Temporary Market (Flea Market) and Eating Place for a Period of 3 Years in “Village Type Development” Zone and Area shown as “Road”, Lots 398(Part), 399SA(Part), 399RP(Part), 400 (Part) and Adjoining Government Land in DD109, Kam Sheung Road, Kam Tin, Yuen Long, New Territories
(Application No. A/YL-KTS/1139)

Drainage Submission in support of

Responses to Comments from Government Departments on Planning Application

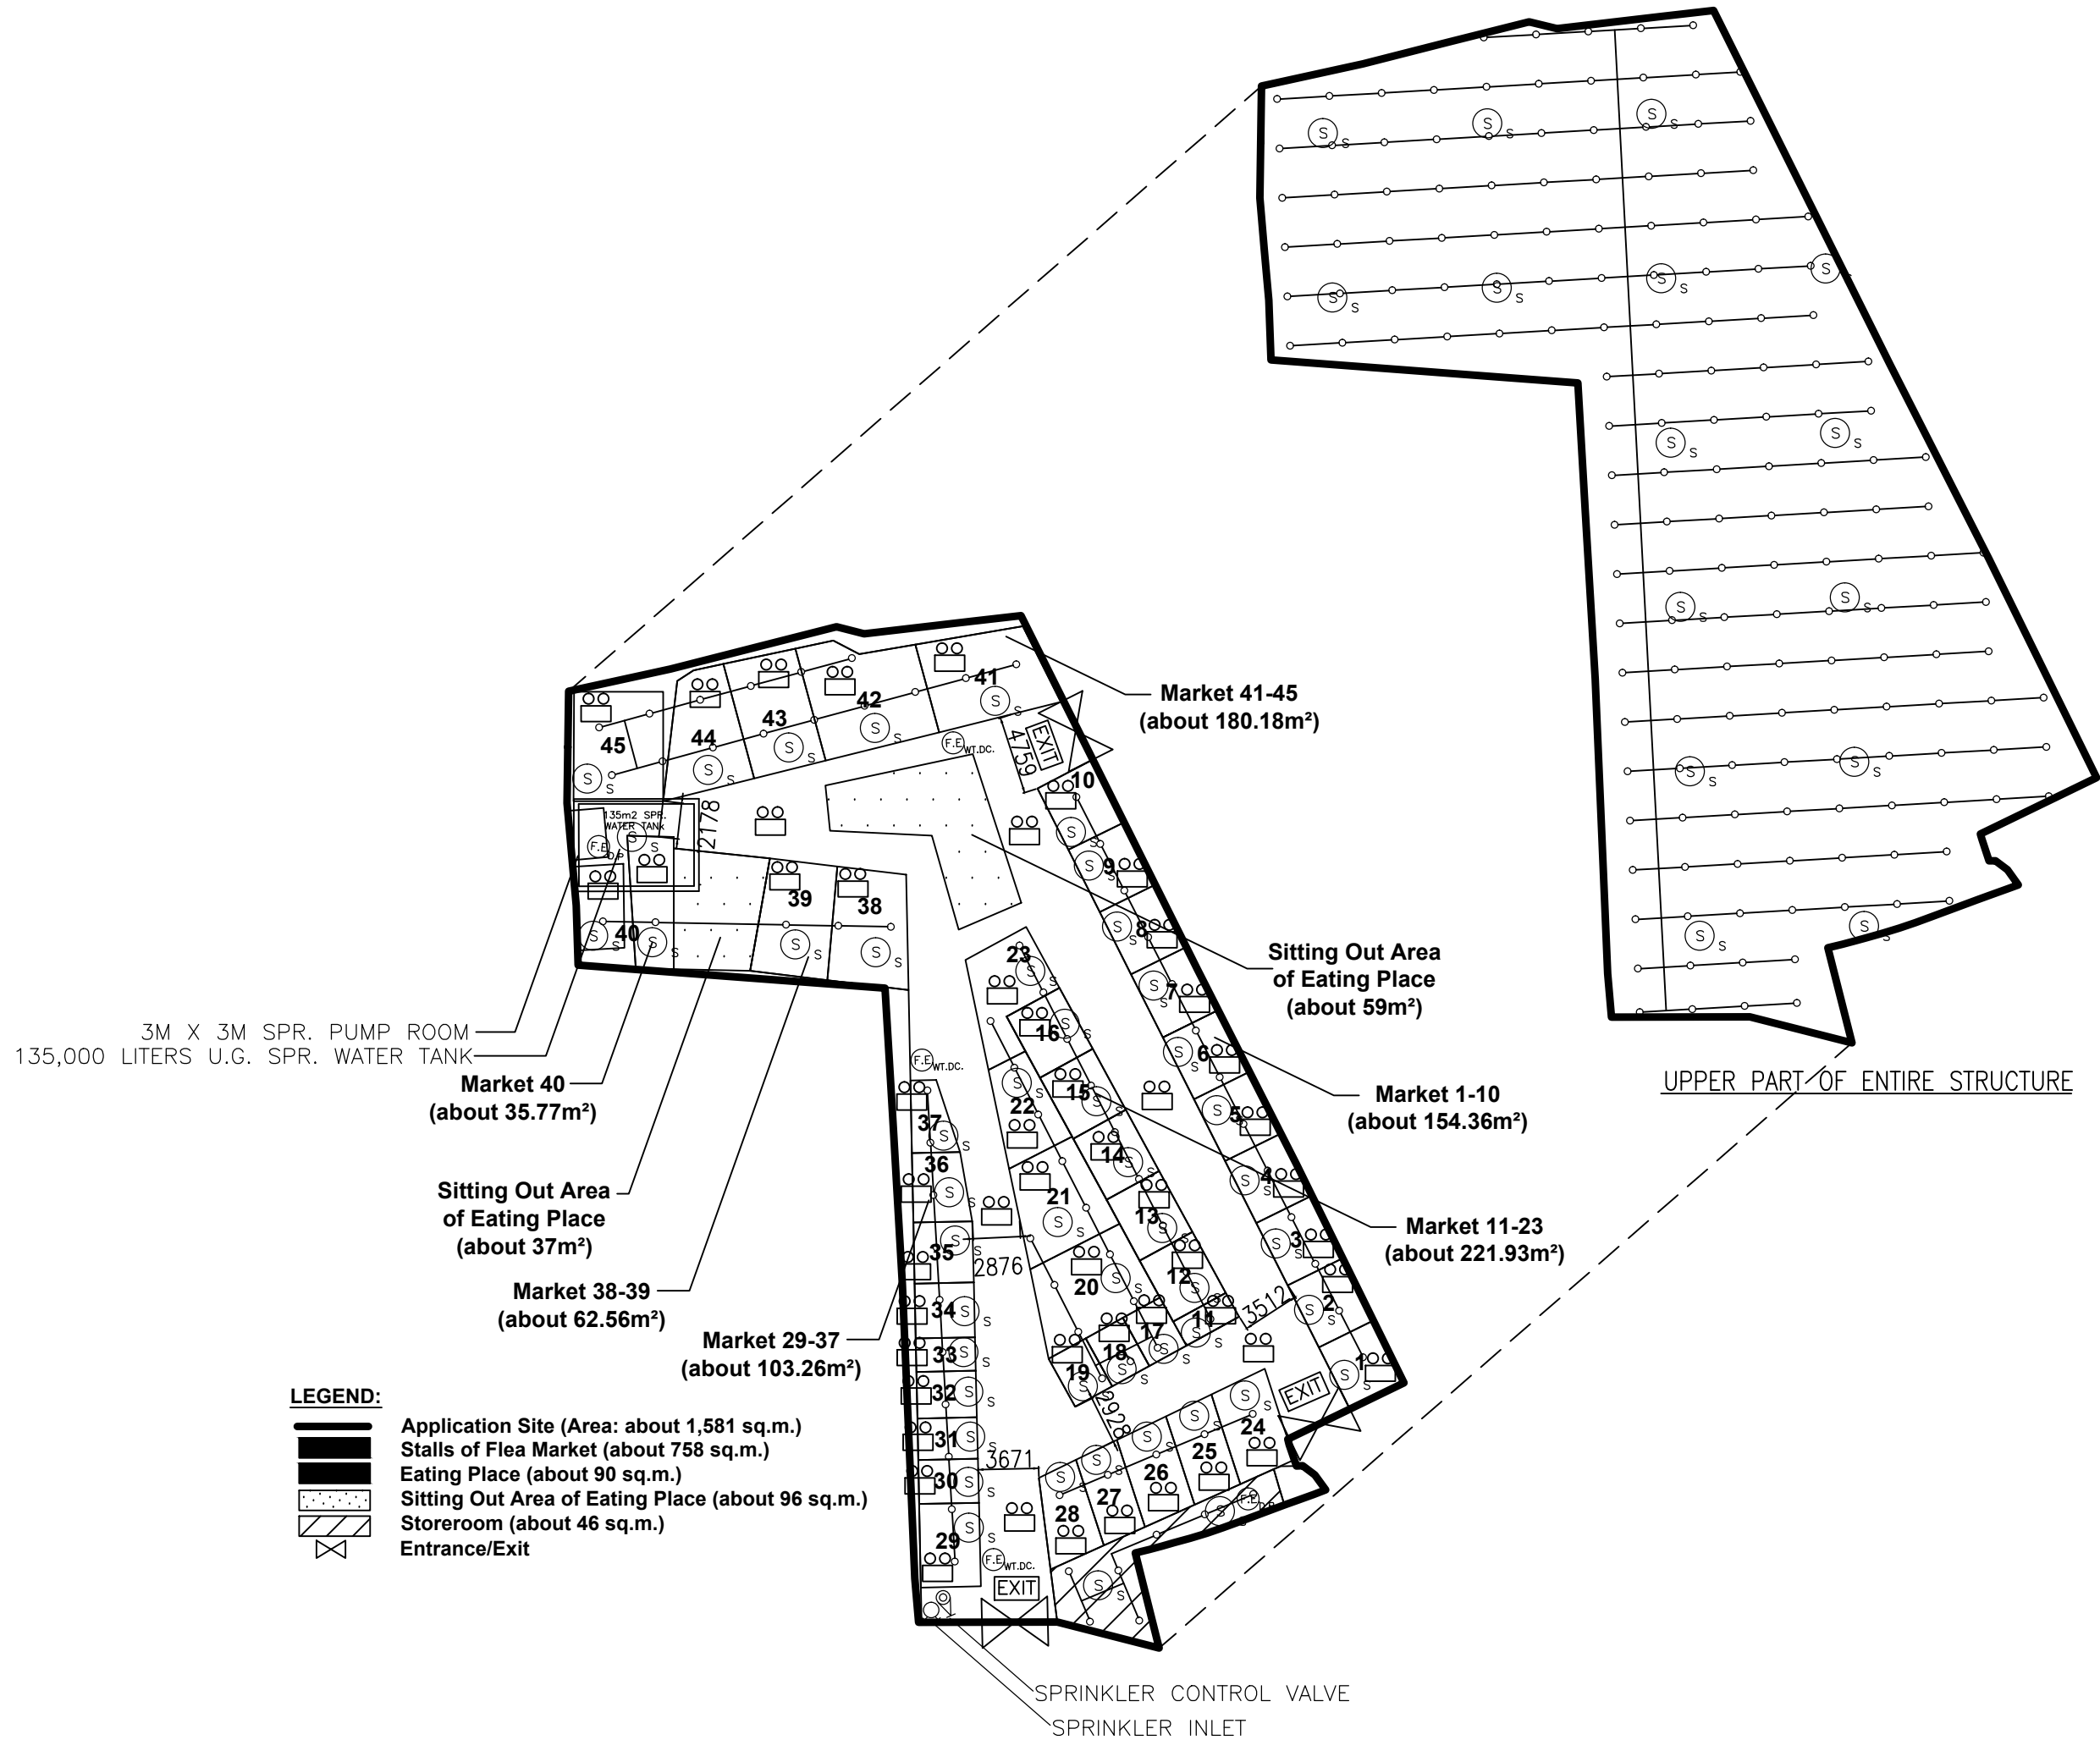
COMMENTS	RESPONSES
Drainage Services Department (DSD)	Applicant
i. In view of the latest climate change effect and the size of the site area, please review and upgrade the existing and the proposed drainage facilities accordingly. Please make reference to the latest Technical Note No. 1 issued by DSD for more details;	The latest Technical Note No. 1 issued by DSD was adopted in the updated Drainage Submission
ii. Peripheral surface channels shall be provided along the site boundary (i.e. the western side of the application site (the Site), etc.) at the existing/original ground level (instead of the revised ground level) to collect the surface runoff accrued on the Site and to intercept the overland flow from the adjacent lands. For Section X-X, the proposed peripheral surface channel should be located within the Site;	There are existing buildings/structures/fence walls of the adjacent developments adhering to the external walls of the existing structure of the Application Site along the southern, western and northern boundary of the Application Site as shown in the following photos (details refer to the aerial photo in the Section 3, Plan 2 and Plate 3, 6 and 8 of the updated Drainage Submission): <u>Southern side</u>

COMMENTS	RESPONSES
iii. For Plan 5, please use clear legend(s) or color(s) showing the proposed drainage facilities with catchpits for review;	Plan 5 has been amended accordingly.
iv. For Section X-X, please advise whether the proposed upgrading works (from 225mm u-channel to 375mm u-channel) will be carried out and maintained by the applicant at his own cost. If affirmative, please clearly state the above on the drainage plan for record;	The proposed upgrading works (from 225mm u-channel to 375mm u-channel) will be carried out and maintained by the applicant at his own cost. It is stated on the drainage plan (Plan 5 of the updated Drainage Submission) for record.

v. The gradient of the proposed and the existing u-channels should be shown on the drainage plan;	The gradient of the proposed and the existing u-channels are now shown on the drainage plan of the updated Drainage Submission.
vi. Please advise if any site formation/levelling works to be carried out under this application. Cross sections showing the existing and proposed ground levels of the captioned site with respect to the adjacent areas should be given;	The subject development (the 'Red Brick House') has been operated as the currently applying use not later than 2008. No site formation/levelling works would be carried out under this application. Section X-X and Y-Y of the Application Site are shown on Plan 3 .
vii. The cover levels and invert levels of the proposed u-channels, catchpits/sand traps should be shown on the drainage plan;	The cover levels and invert levels of the proposed u-channels, catchpits/sand traps are now shown on the drainage plan of the updated Drainage Submission.

COMMENTS	RESPONSES
x. Referring to Plate 10, the said existing 225mm channel should not be covered by wooden board/anything and this drainage facility does not indicate on the drainage plan (Plan 5);	The obstruction upon the concerned existing 225mm channel was removed (please refer to the plate in the following).  The channel is an internal channel within the existing structure and therefore is not shown on the drainage plan (Plan 5) for clarity.
xi. The existing u-channels, to which the applicant proposed to discharge the stormwater from the subject site was not maintained by this office. The applicant(s) shall resolve any conflict/disagreement arisen for discharging the runoff from the Site(s) to the proposed discharge point(s). In the case that it is a local village drains, District Officer (Yuen Long) should be consulted. Moreover, the applicant(s) should ensure that this drainage system and the existing downstream drains/channels/streams have adequate capacity to convey the additional runoff from the Site(s). Regular maintenance should be carried out by the applicant(s) to avoid blockage of the system;	Noted, agreed and will strictly follow.
